Revision "B" The Traffic Group, Inc. 410-931-6600 Fax 410-931-6601	REVISIONS		APPROVALS		
			TEAM LEADER, TRAFFIC ENGINEERING DESIGN DIVISION		
			ASST. CHIEF, TRAFFIC ENGINEERING DESIGN DIVISION		
			CHIEF, TRAFFIC ENGINEERING DESIGN DIVISION		
January 7, 2002 Relocate ped. pole & conduit. S.H.A. NO.: BW-855-801-412 FDB		DIRECTOR, TRAFFIC & SAFETY		MARYLAND DOT - STATE HIGHWAY ADMINISTRATION Office of Traffic & Safety TRAFFIC ENGINEERING DESIGN DIVISION (Traffic Signal Plan) MD 140 (Reisterstown Rd.) at Valley Centre Entr.	
DRAWN BY: JWJ CHECKED BY: DJD SCALE: 1" = 20' DATE: August 6, 1986		F.A.P. NO.: N/A S.H.A. NO.: BW-855-801-412 COUNTY: Baltimore LOG MILE:		TS NO.: 2103-B T.I.M.S. NO.: E-779 SHEET NO.: 3 OF 4

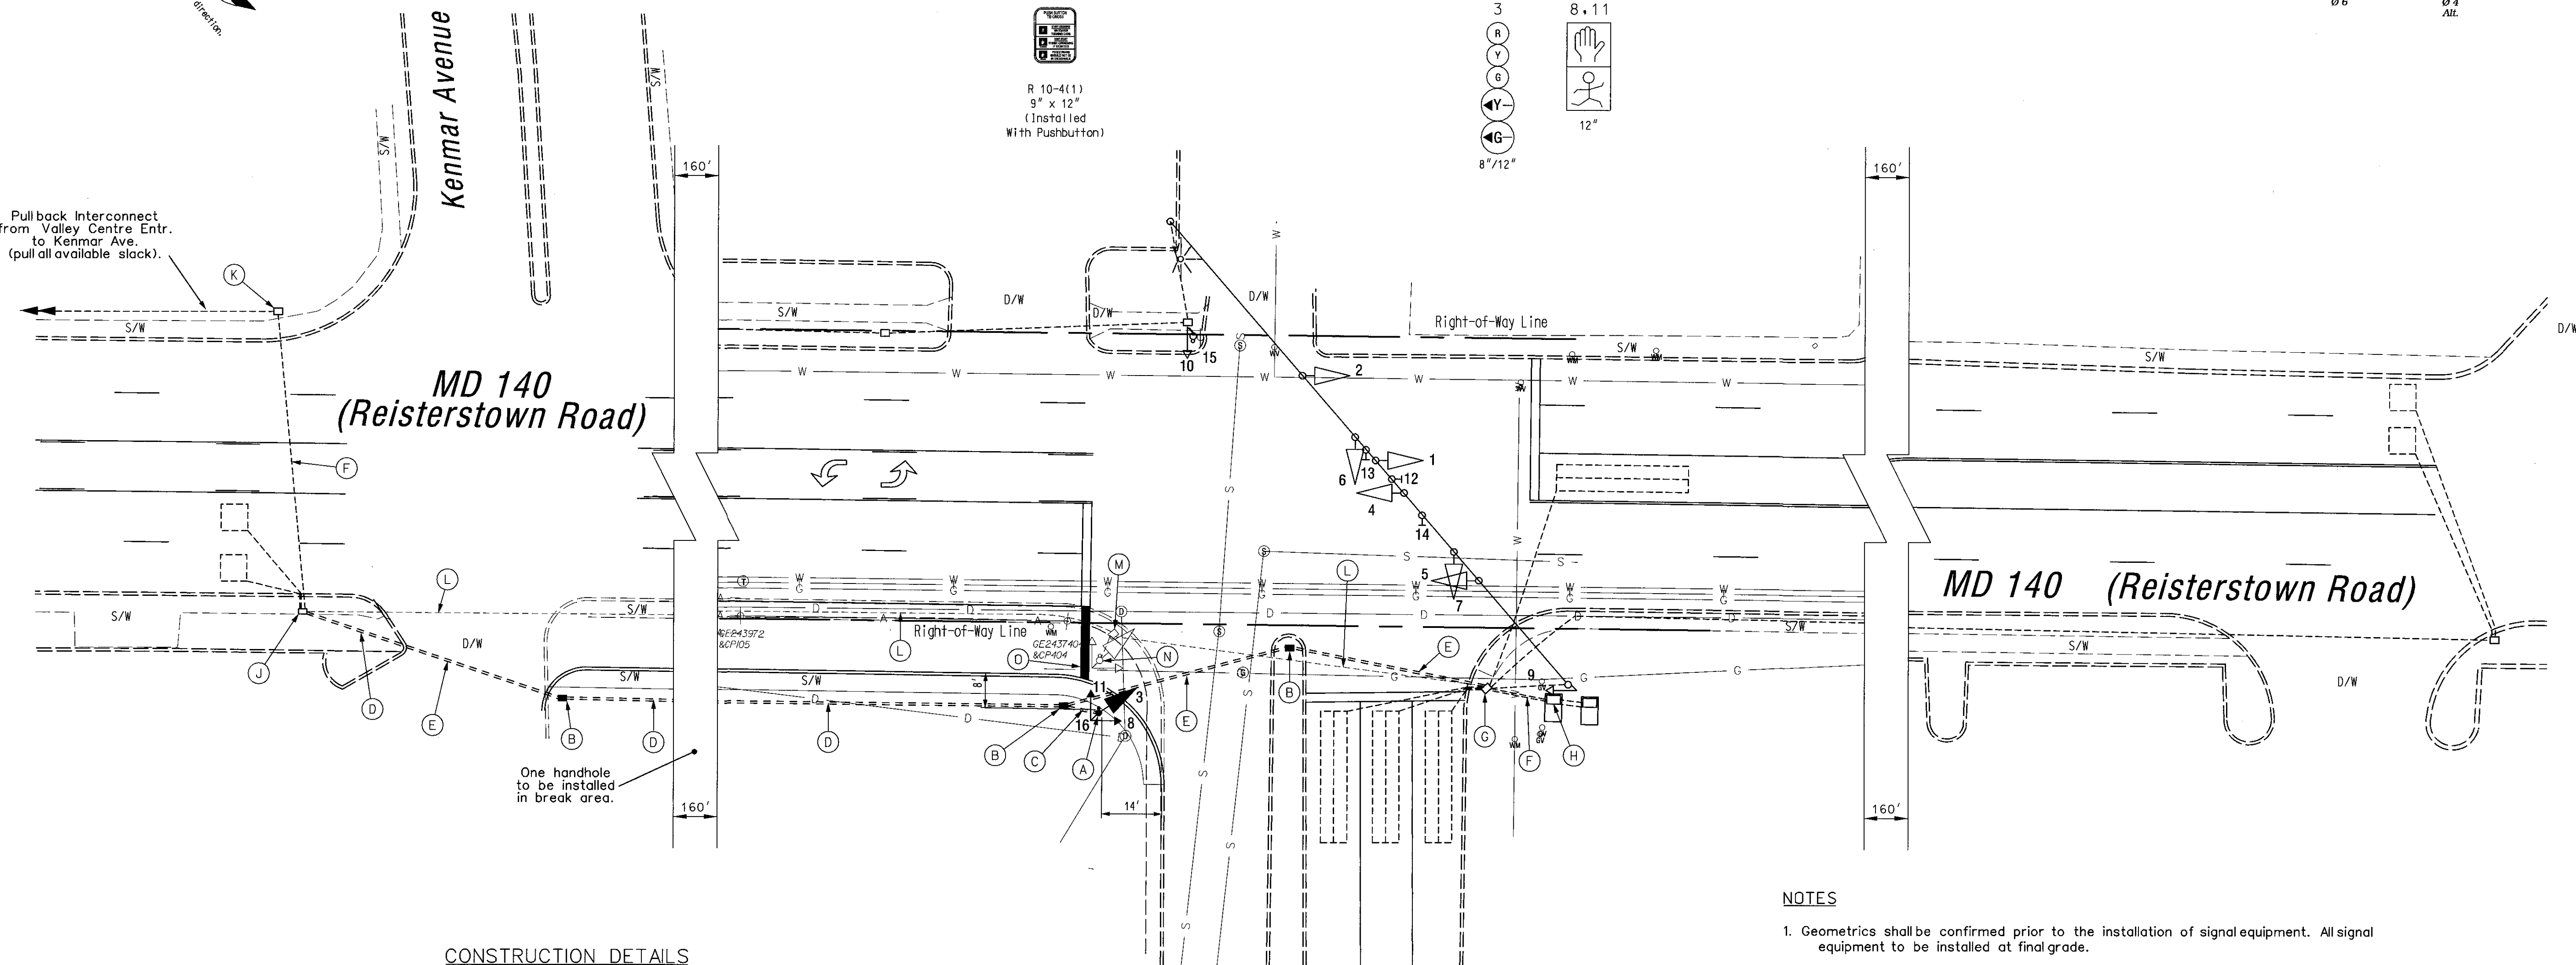
Pull back Interconnect from Valley Centre Entr. to Kenmar Ave. (pull all available slack).

- Install 14 ft. steel pedestal pole on break-away base with signal head, pedestrian heads, pushbutton, and pushbutton sign (Note: one 2 in. PVC elbow).

- Install handhole.
- Install 2 in. polyvinyl chloride [Schedule 80] electrical conduit - trenched.
- Install 3 in. polyvinyl chloride [Schedule 80] electrical conduit - trenched. (Note: Conduit to be installed prior to sidewalk construction).

- Install 3 in. polyvinyl chloride [Schedule 80] electrical conduit - slotted in roadway.
- Use existing conduit.
- Use existing handhole.
- Use existing cabinet/controller.

- Use existing handhole. Splice existing loopwire to new aluminum shielded cable.
- Use existing handhole. Pull back existing interconnect cable from the Valley Centre cabinet and re-run back in new conduit.

- Cap and abandon existing conduit.
- Remove existing handhole.
- Remove existing steel pole and all attached equipment.
- Install 24 in. wide thermoplastic pavement marking - white for stop line.
